# Access Compliance Report

## Public Rights-of-Way

### (Curb Ramps)

| Intersection ID: 45130 | Main Street: DULIN_CREEK_BV | Cross Street: PLAZA_RD_EXT | Location: SW           |

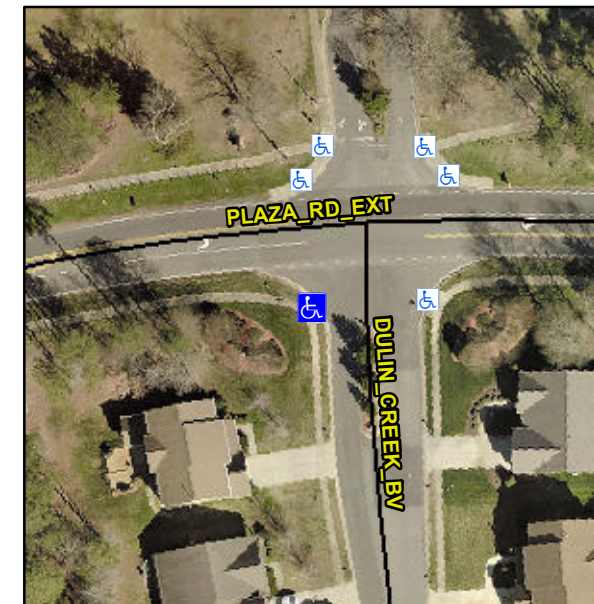
| ADA ID: 1AEB6497C4CA   | Ramp Type: PerpDiag         | Initial Pass/Fail: Fail    | Overall Compliance: No |

**Not Found, R304.5.1, R304.2.2, R304.5.3**

| Compliance | Description           | Data | Compliance | Description                 | Data |
|------------|-----------------------|------|------------|-----------------------------|------|
| N/A        | Ramp Length (in)      | 48.0 | No         | Ramp Slope (%)              | 9.8  |
| No         | Ramp Width (in)       | 47.0 | No         | Ramp XSlope (%)             | 3.8  |

**Remove & Replace Curb Ramp With Two New Directional Ramps or Equivalent.**
